Planning Commission

A request for site plan approval for improvements to the property known as Central Lofts, 500 Erie Street.

**Re: Site Plan Review, Central Lofts Condominiums
500 Erie Street, South Haven, MI**

RE: Final Site Plan Review
Central Lofts Phase II
500 Erie Street

SITE PLAN

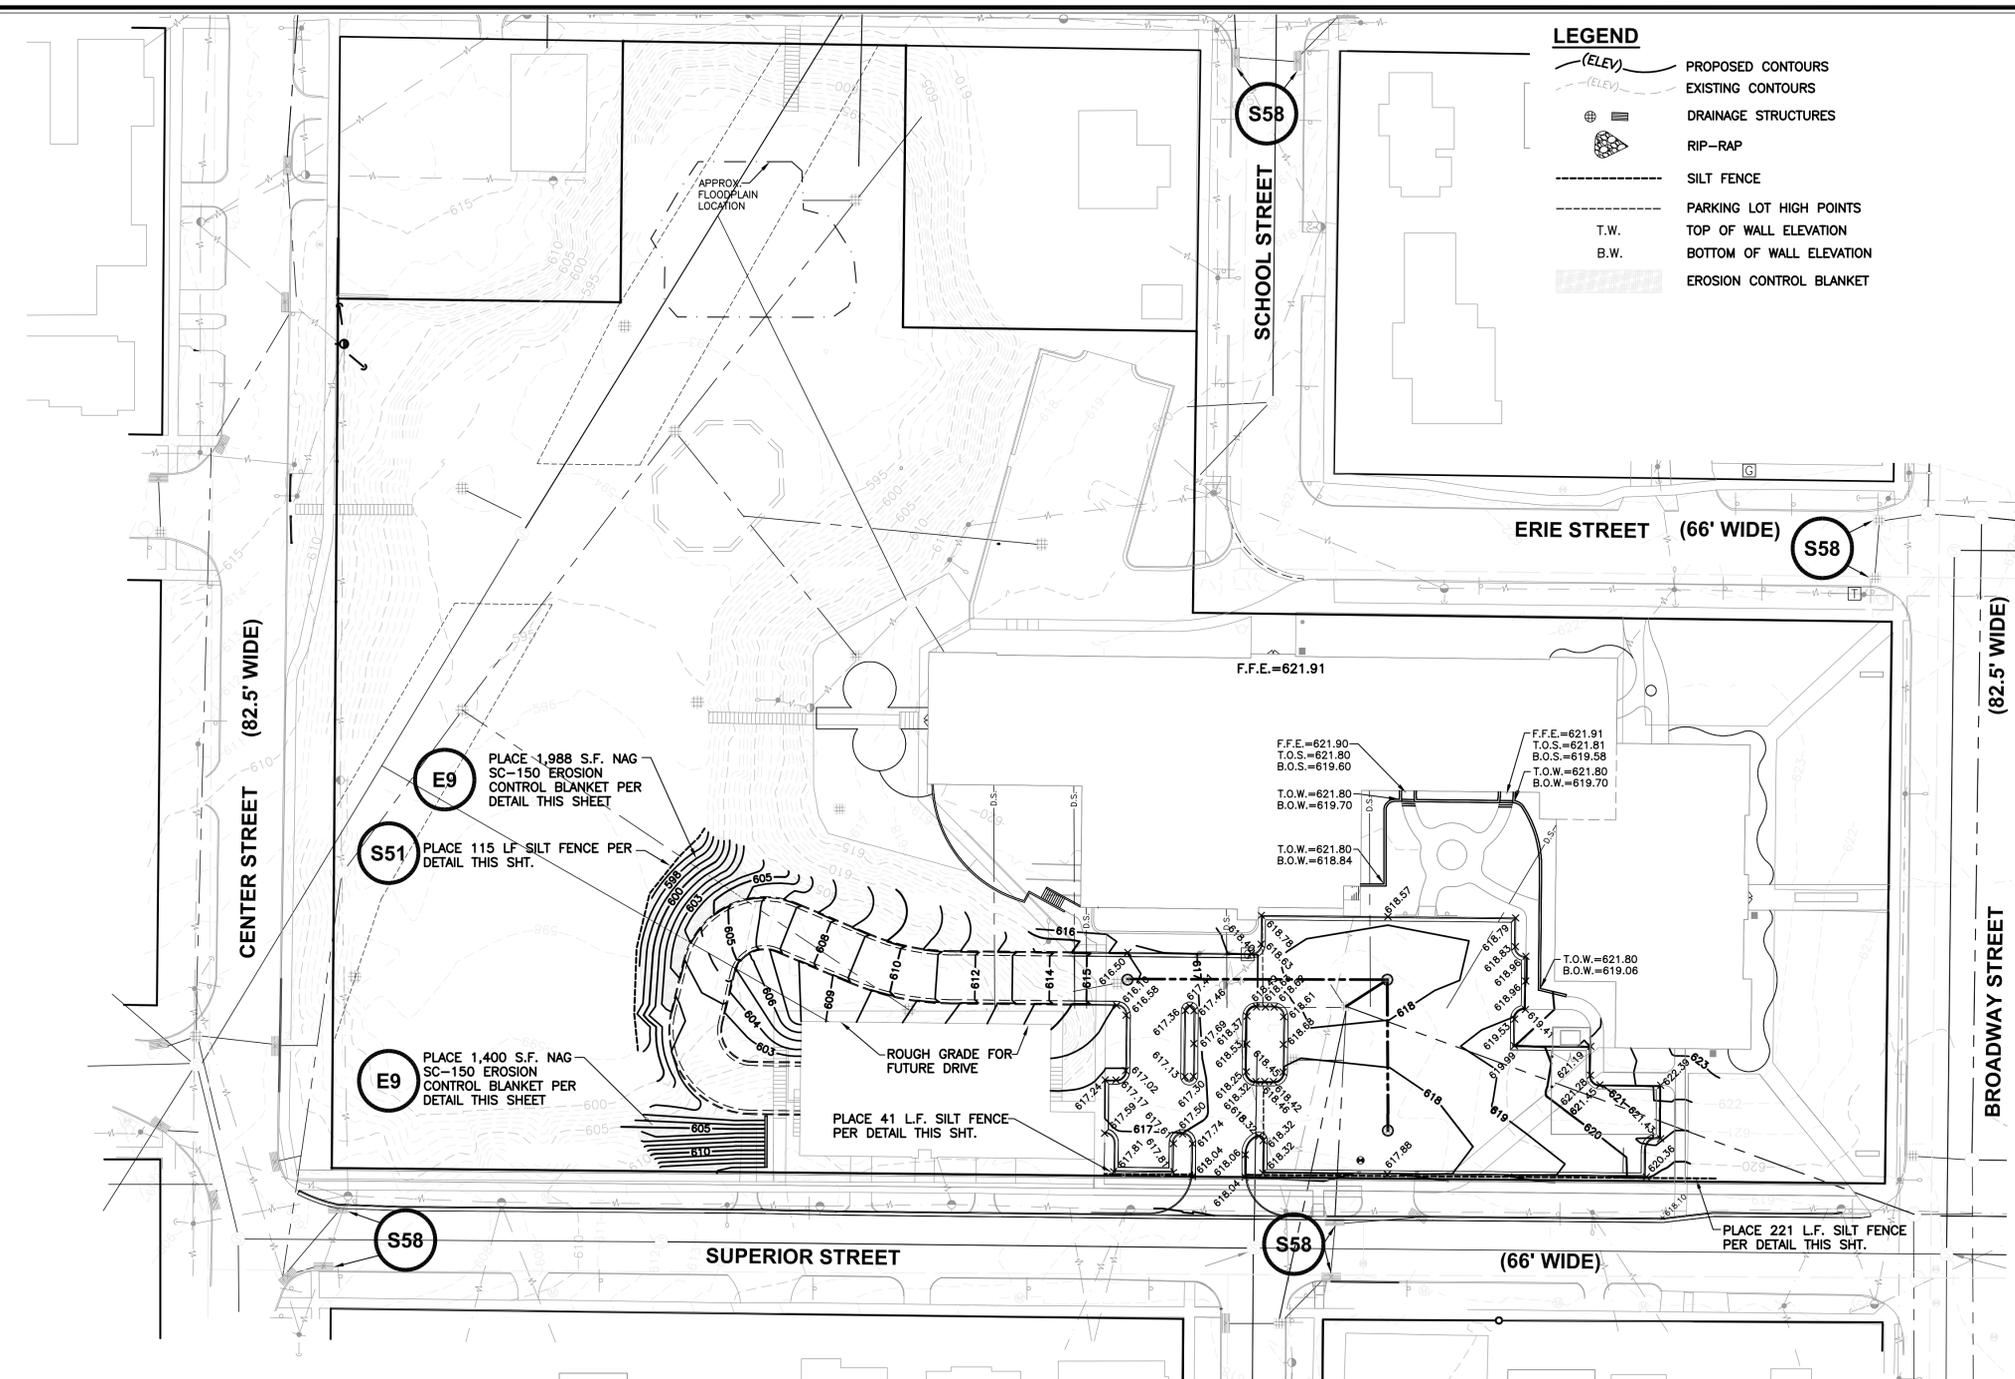
The site plan illustrates placement of a dumpster enclosure within the new parking lot. It is recommended that the concrete pavement section be utilized for the dumpster pad and garbage truck maneuvering area. The location of the dumpster pad is such that it may be difficult or impossible for the garbage collection vehicle to access the dumpster. It is recommended that an alternate location be proposed that permits adequate vehicle access.

Paragraph 4: The dumpster enclosure has been moved to provide additional maneuvering area. Concrete pavement is shown through the maneuvering area as shown on sheet C2.

Paragraph 3: The entrance drive has been revised to be 25' wide and the entering radius 20' on sheets C2 & C5 (per discussion with Larry Halberstadt, PE on June 7, 2013). A road right-of-way permit will be obtained prior to commencing any work in the Superior Street right-of-way.

UTILITY PLAN

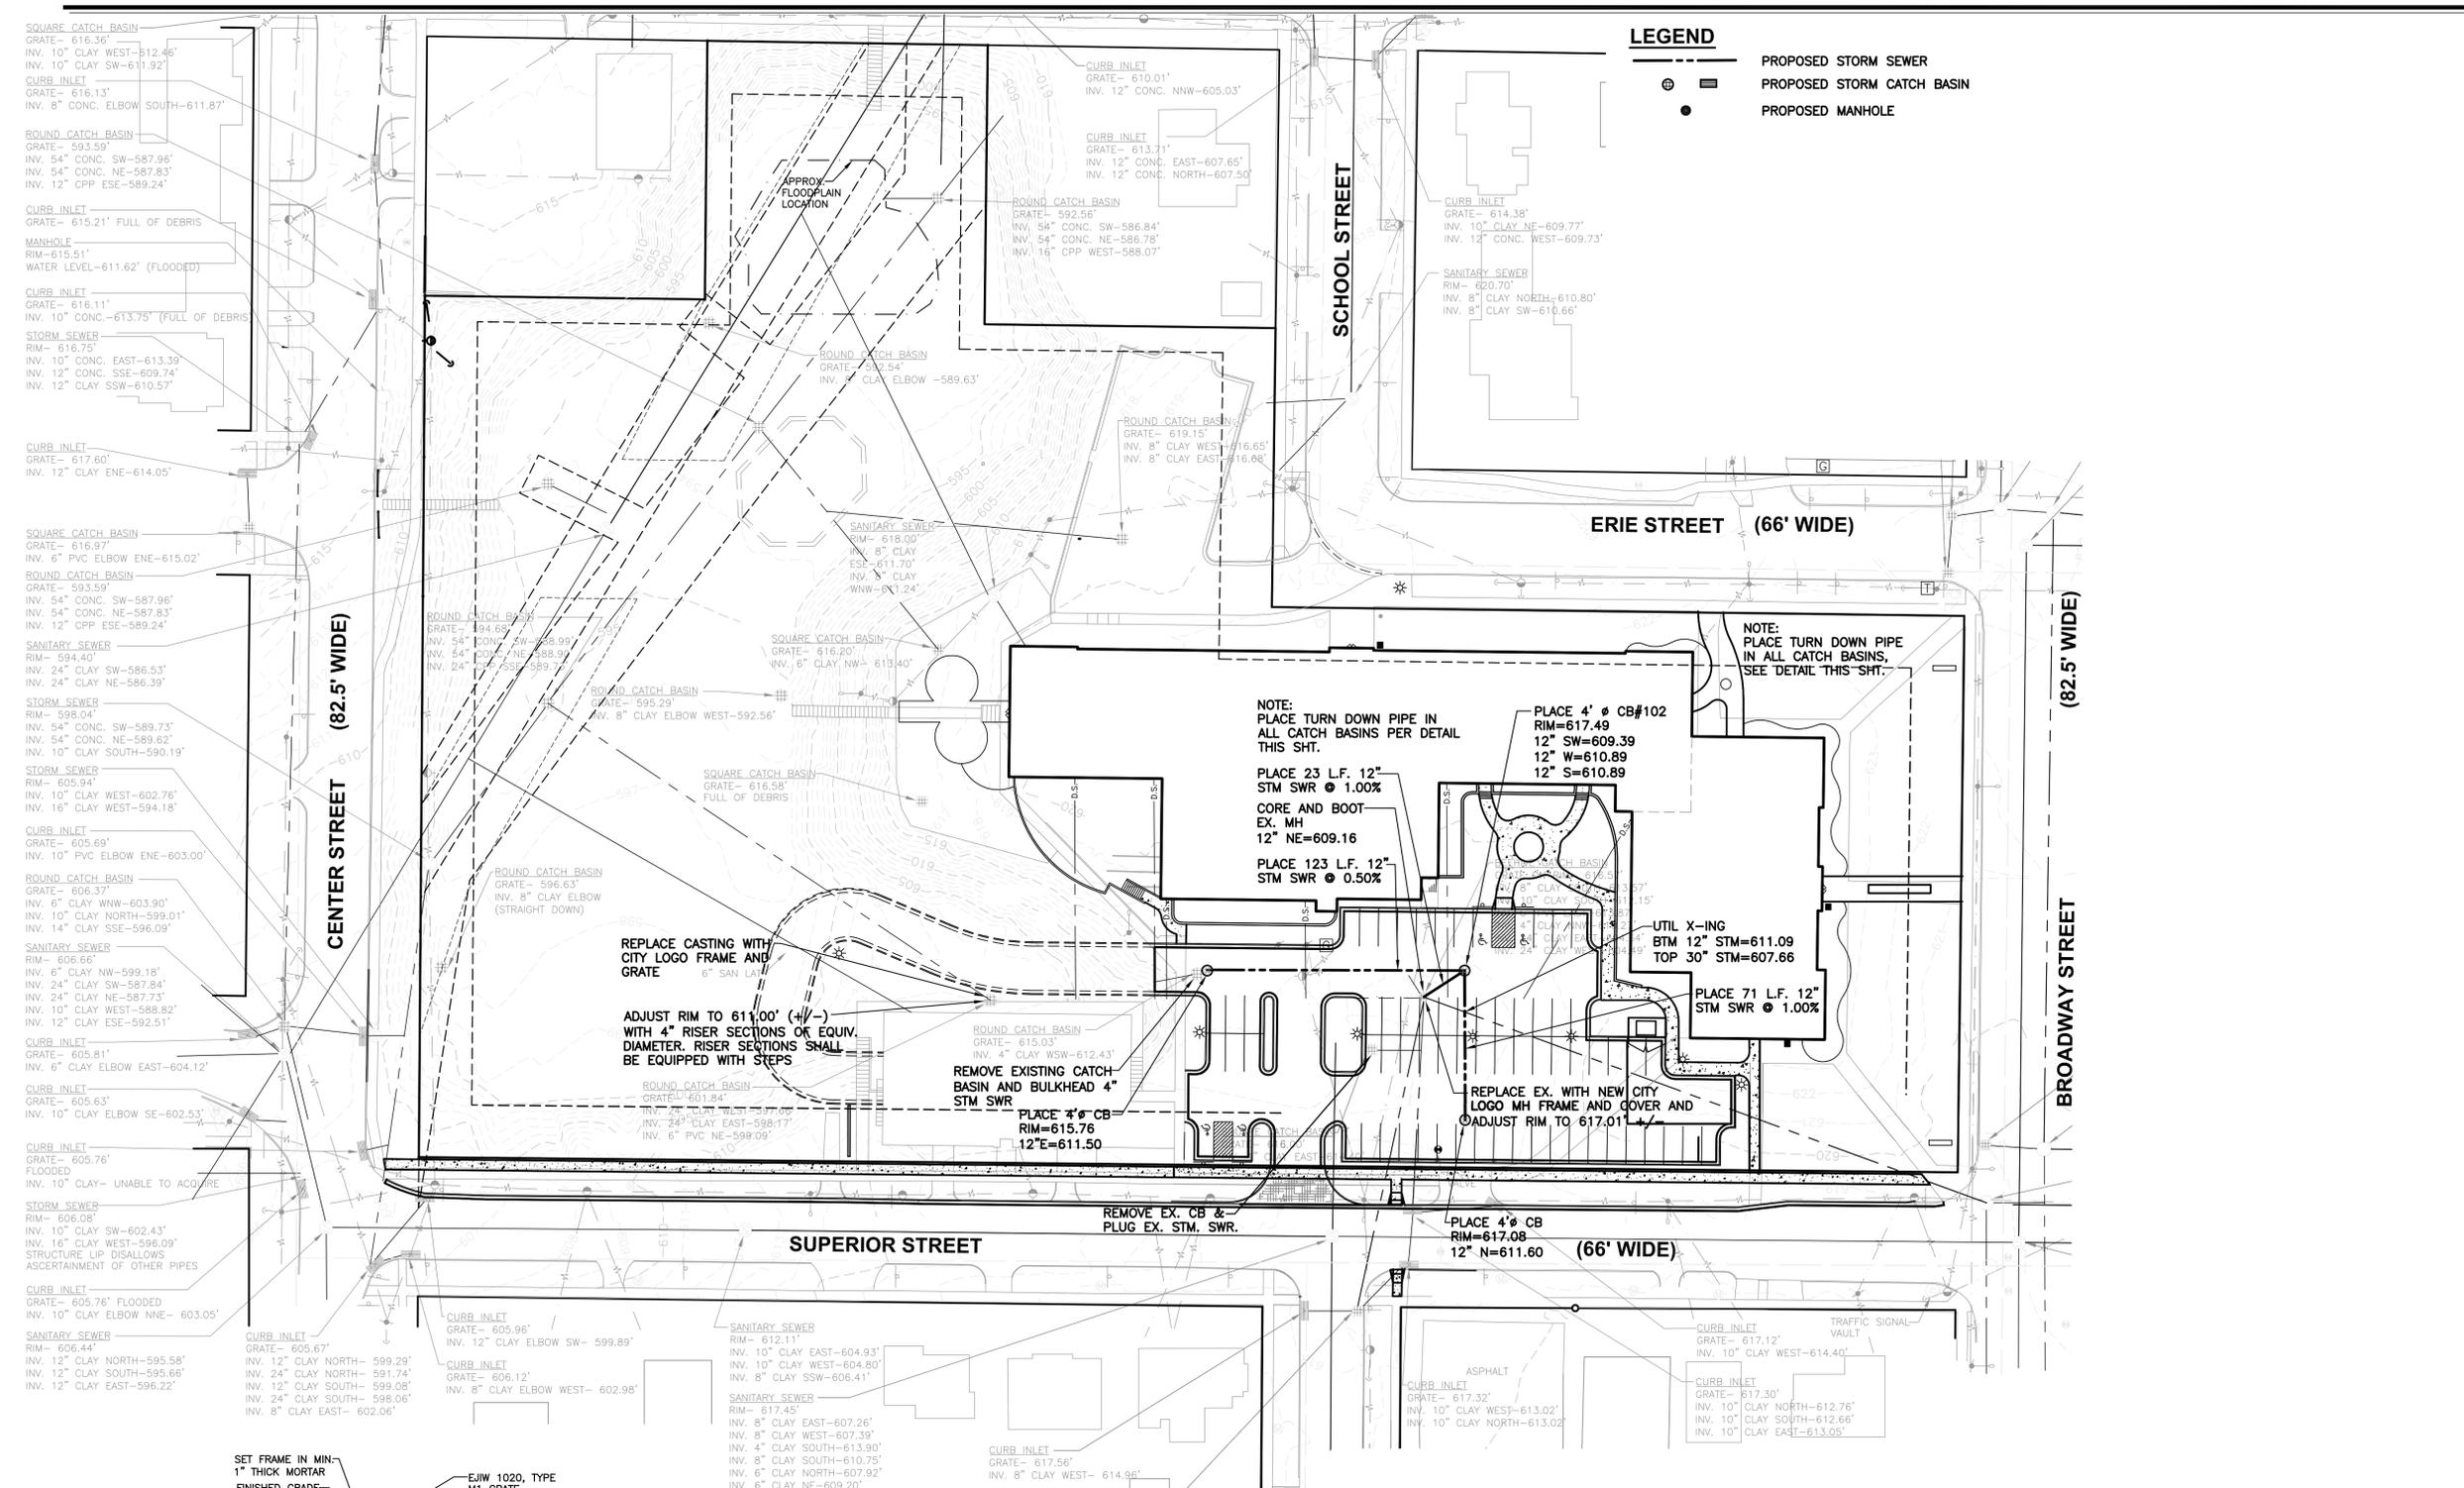
There is an existing public storm sewer system that crosses beneath the proposed parking lot and is used to convey drainage from MDOT and City streets to the Peterson County Drain. The site plan illustrates a series of private storm sewers and catch basins that will connect to the public storm sewer system via an existing catch basin. The proposed storm sewer layout in the parking lot is acceptable. The existing catch basin within the parking lot shall be adjusted to finished grade and a new City Logo manhole frame and cover shall be installed. There is an existing catch basin near the proposed westerly catch basin. This catch basin shall be removed and the storm sewer outlet plugged. Provisions shall be made for overland conveyance of storm water to the Baer Park area in the event that the capacity of the public storm sewer system is exceeded. These provisions should include providing a low point along the westerly edge of pavement and providing slope stabilization at the potential overflow location.

The parking lot grading plan is acceptable to the Engineering Department. However, the proposed grading along the east and north wall of the building at 525 Superior Street is incomplete. There are existing retaining walls and stairways that were removed by the previous developer. The removal of these should be shown on the site plan. In addition, a man door has been installed in the north wall of 525 Superior Street on the basement level. This door has an exit elevation of 603.00. The proposed grading plan illustrates approximately 7 feet of fill being placed in front of this door. The grading plan should be updated as required to accurately reflect the fill that will be placed against the east and north building walls. The man door will need to be relocated to the west building wall to permit this grading to occur. In addition, there is a catch basin on the public storm sewer line near the north building wall of 525 Superior Street. This catch basin needs to be adjusted to finished grade and equipped with a new City Logo manhole frame and cover. The proposed change in finished grade is approximately 9 feet. The manhole should be reconstructed with a riser section diameter that matches the existing diameter, but is no less than 4 feet. The new riser section shall be equipped with steps to provide interior access.

Paragraph 7: Notes have been added to sheet C4 to install City Logo manhole frames and covers on the existing public storm sewer system crossing beneath the proposed parking lot.

A Note has been added to sheet C4 to remove the existing catch basin near the proposed westerly catch basin and bulkhead the existing 4" clay storm sewer.

The note to adjust the existing catch basin rim (sheet C4) has been revised to include installation of a City Logo manhole frame and cover with the minimum diameter riser and steps.
